| VENTILATOR                             |  | R11R-40LPS-4M-5756                 |  |
| KOD A:<br>CODE                         |  | 0311-4-0329<br>0311-4-0329         |  |
| VERZIJA ARTIKLA:<br>REVISION ARTICLE:  |  | AD                                 |  |

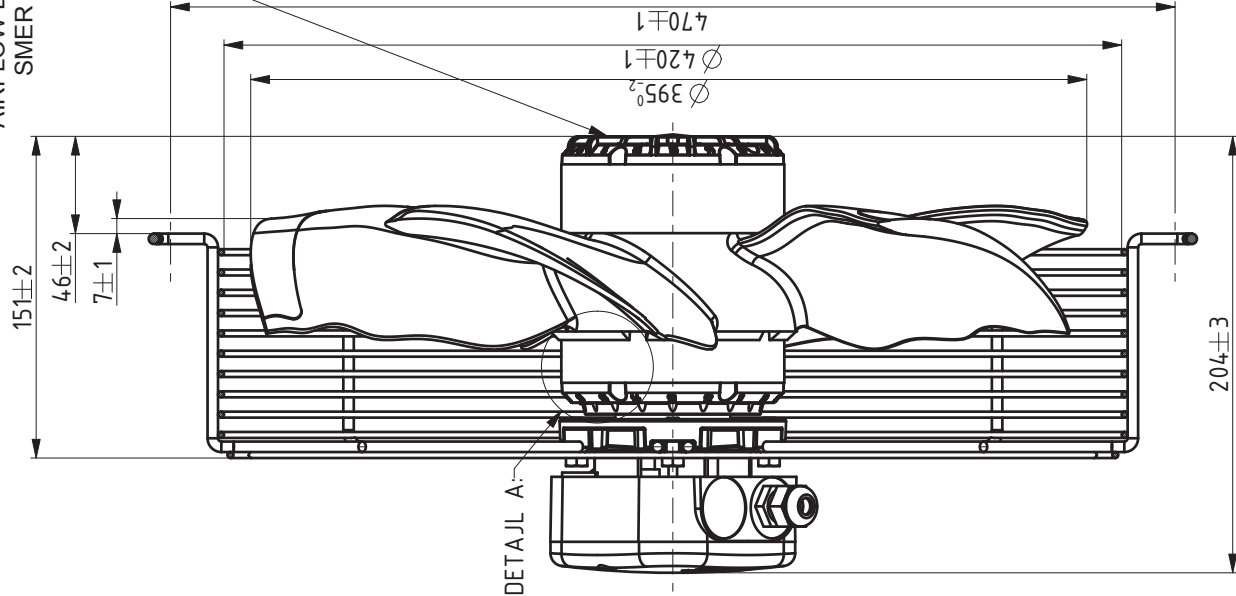
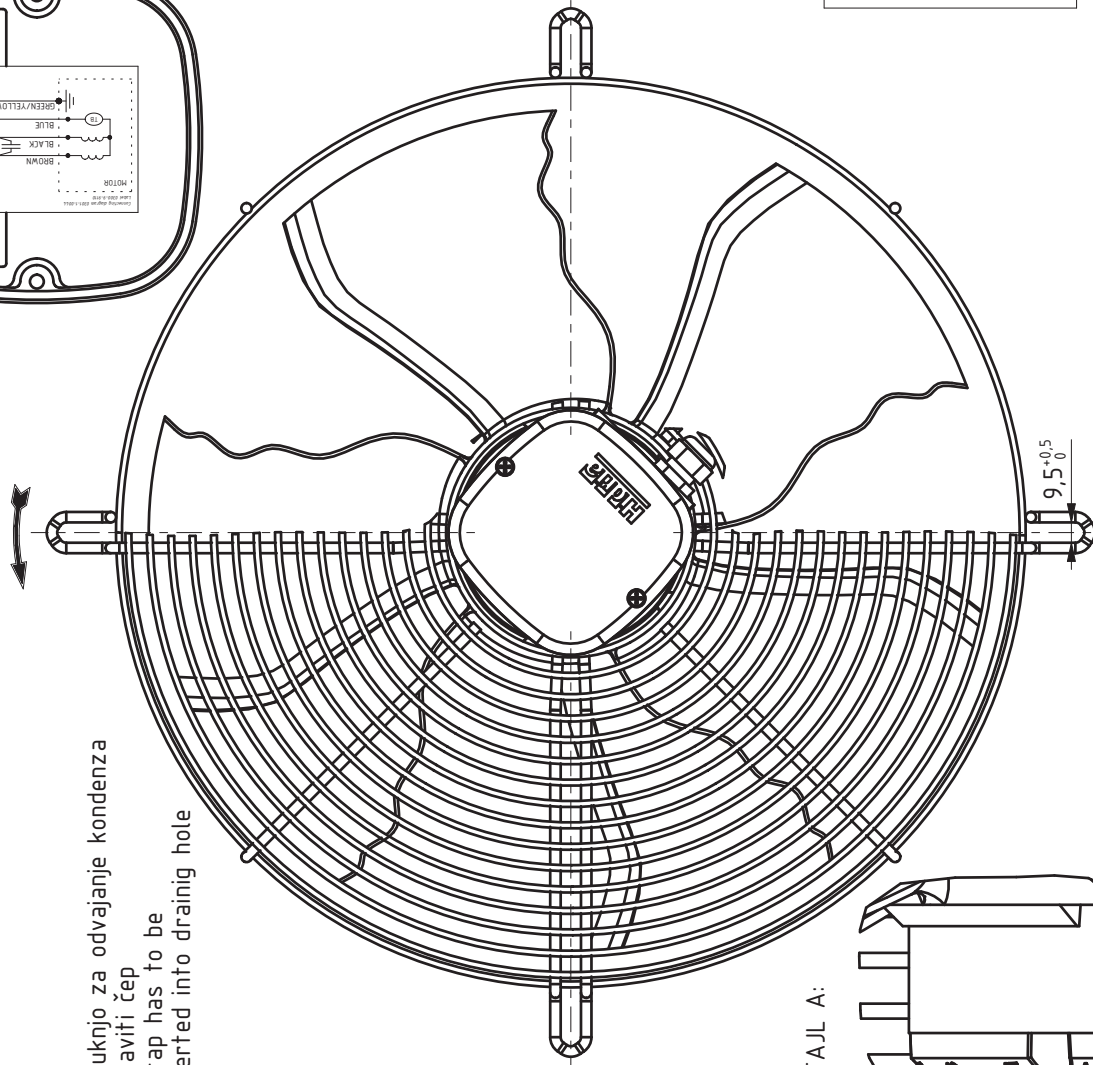
| 1 | D              | Na ribsi se dopolni opombo za ležanje, doda se: primerni za -4,0°C do +14,0°C. Spremeni se verzija z AC v AD. Ribsa v Windchillu je skladna z ribso v arhivu. | 06.05.13 | Jure L. |

- ventilator z zatesnjenimi ležaji, primerni za  $-40^{\circ}\text{C}$  do  $+140^{\circ}\text{C}$
- fan with sealed bearings, suitable from  $-40^{\circ}\text{C}$  to  $+140^{\circ}\text{C}$
- navodilo za kontrolo ventilatorja 0301-1-4660
- checking instruction 0301-1-4660

DETAIL A:  
1:1

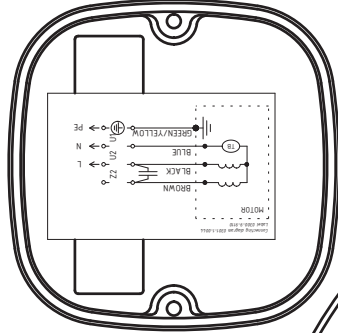
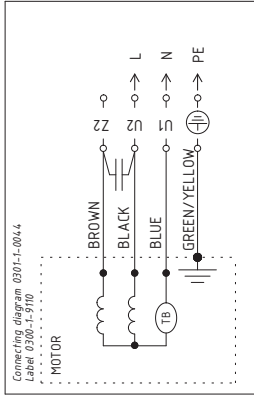
A tap has to be inserted into drainig hole
